## **8.14. Draft North Sydney DCP 2013 amendment: North Sydney CBD - Commercial tower setbacks and separation - Post-exhibition report**

To seek Council's endorsement to amend the built form guidelines that apply to commercial towers in the North Sydney CBD under the North Sydney Development Control Plan 2013, following public exhibition of a draft amendment and consideration of submissions.

Figure 1: Key issues highlighted in submissions received during the public exhibition of the Draft DCP amendment.

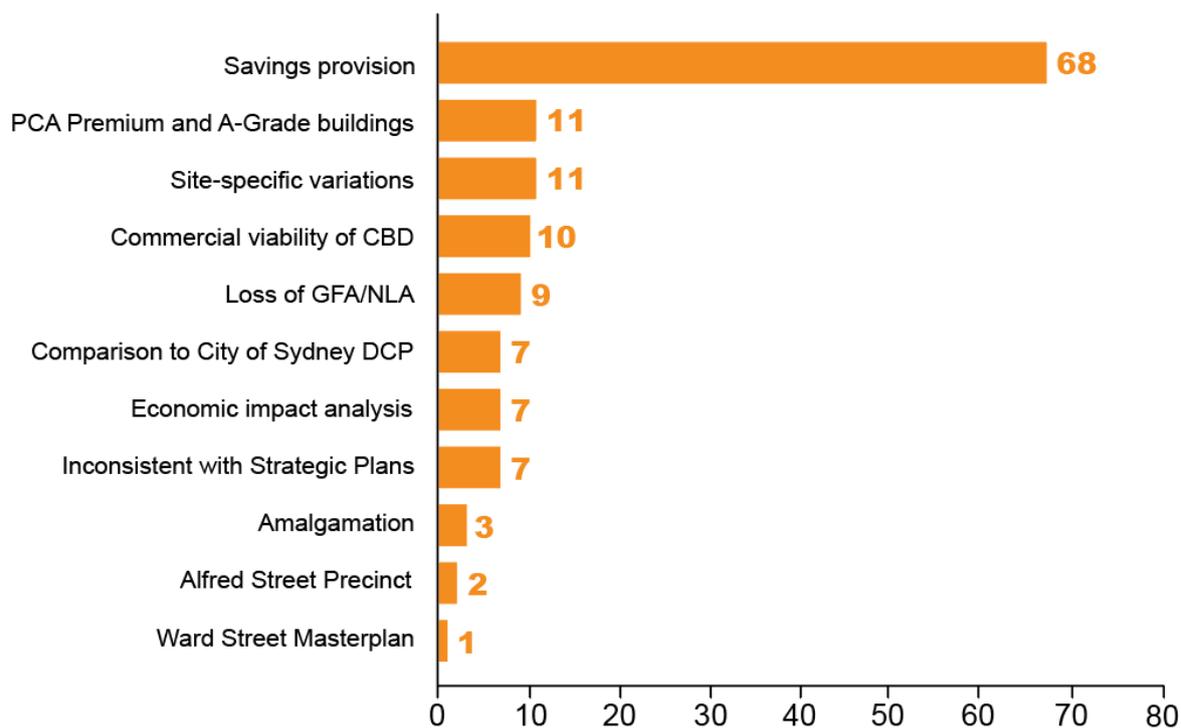
Key issues raised in the submissions are discussed in detail in this section. The number of submissions received that related to each issues is shown in Figure 1.
